Subject: The Dow Chemical Company- License No. R-108; Docket No. 50-264

Subject: Dow Chemical Company- License No. R-108; Docket No. 50-264. Responses for the July 11, 2011 NRC letter "REQUEST FOR ADDITIONAL INFORMATION REGARDING FINANCIAL QUALIFICATIONS FOR THE DOW CHEMICAL COMPANY TRIGA RESEARCH REACTOR LICENSE RENEWAL (TAC NO.ME1595)" submitted in support of the license renewal.

Dow is providing response in support of its Application for License Renewal for the Dow TRIGA research reactor. The response to the RAI is organized by individual question. Each question will be reiterated and our response will follow.

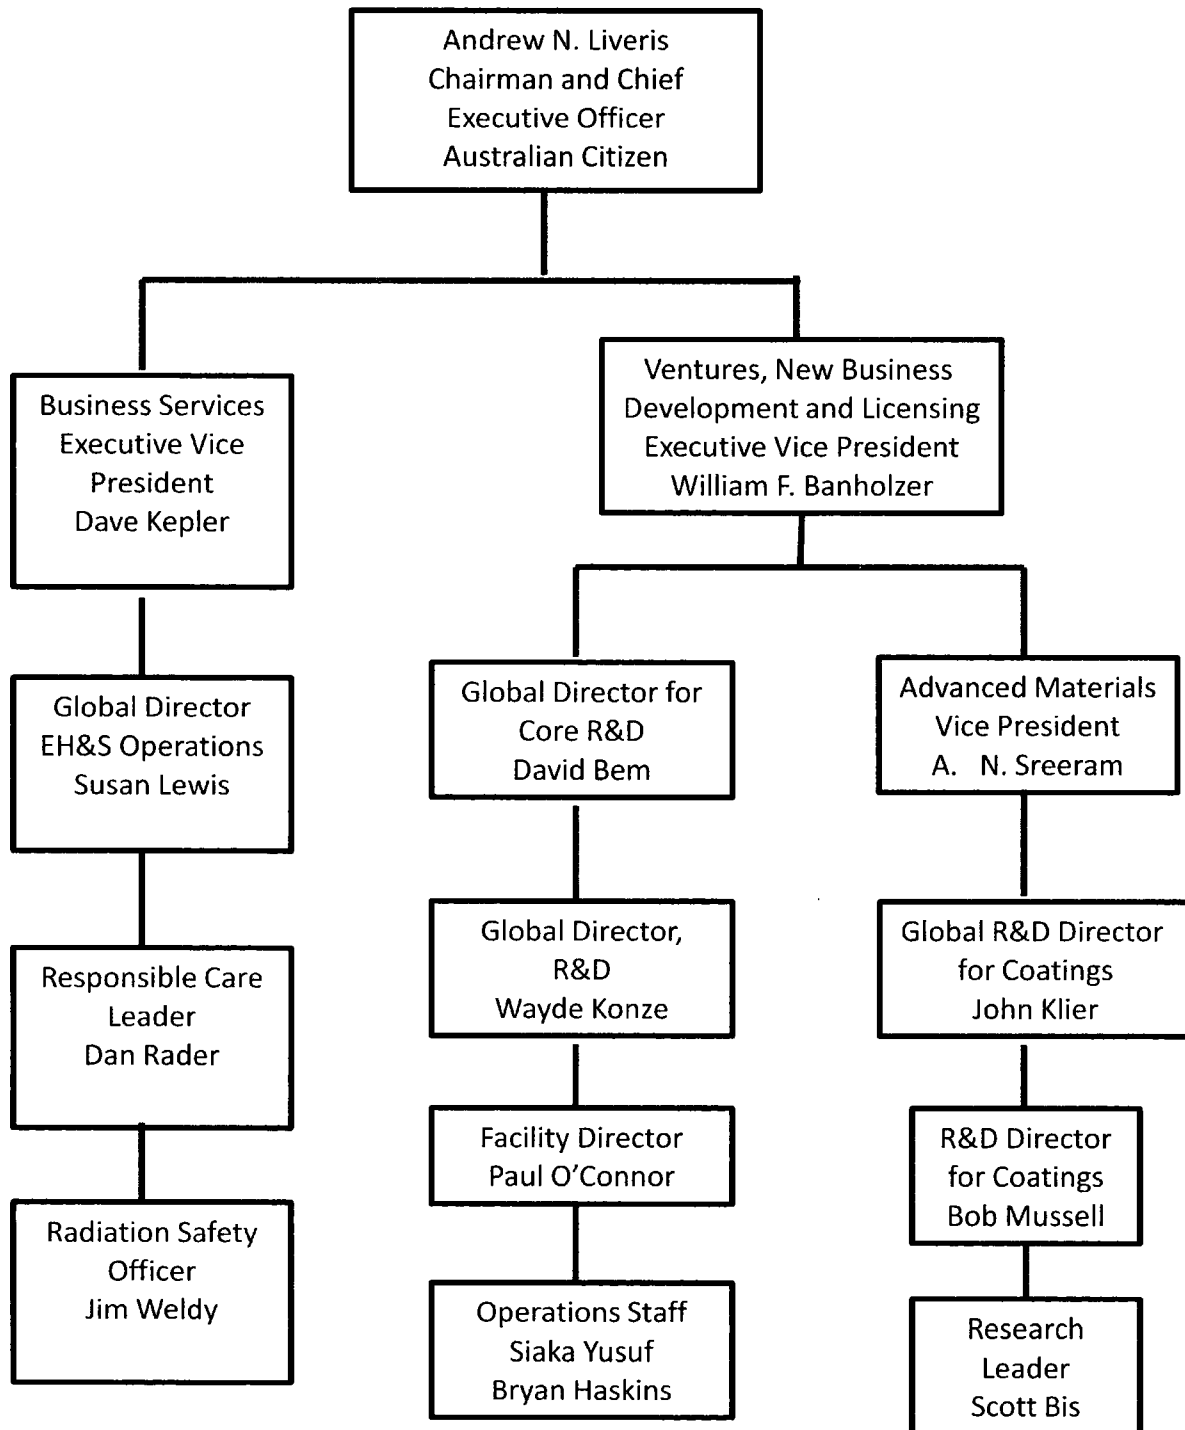
b) By letter dated December 7, 2010, supplement to the application, it was stated that "Physical access to the reactor and [SNM] is restricted to [United States] citizens." Physical Security is discussed, planned and approved with individuals on the Reactor Operations Committee. The Reactor Operations Committee is restricted to [United States] citizens. Please identify to whom the Reactor Operations Committee, which is comprised of citizens of the U.S., reports within the Organizational Chart included in the April 4, 2011, submittal. If the individual(s) are not included within the Organizational Chart, please provide the names, addresses, and citizenship of those who have managerial, financial, or staffing authority over the Reactor Operations Committee.

Updated DTRR organization information as of June 4, 2011 is shown in the chart below. Wayde Konze (US Citizen) has replaced Sandeep Dhingra as the Global Director for Analytical Sciences and the ROC Chair, Paul O'Connor (US Citizen) has replaced Melinda Krahenbuhl as the Facility Director. These changes were communicated to the NRC in a May 23, 2011 letter.

The ROC is currently comprised of Wayde Konze, Paul O'Connor, Jim Weldy, Siaka Yusuf, Michael Buchmann and Jay Romick. All members of the ROC are US Citizens. Two current members of the ROC, not shown directly in this organizational chart, are Michael Buchmann and Jay Romick, both former licensed Senior Reactor Operators of the DTRR. These members have line management that reports up through William F. Banholzer in Dow's R&D organization.

Michael Buchmann reports to David Bem. Jay Romick reports to Scott Bis (US Citizen), who reports to Bob Mussell (US Citizen), who reports to John Klier (US Citizen), who reports to Attigana Sreeram (US Citizen), who reports to William F. Banholzer (US Citizen).
